PCN – Process Change Notification

Change:	PA/SGP/SGGP/ILA/GLA/GGBLA Series Products	
Date:	2016/09/08	
Author	Bonnie Chen

PCN-16-8-052/A Page 1 of 3

Illustration of Change Old Package

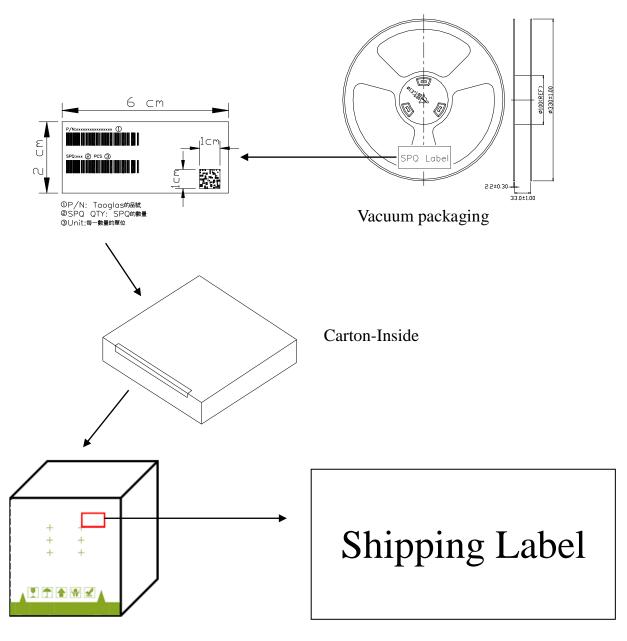
1. Amend Package (follow MSL III), in order to keep Taoglas SMT series products have good storage conditions before it using. The package need to be put desiccant and humidity indicator card into the vacuum bag. And, we will mark the package standard follow the MSL III level labels on the packaging carton.
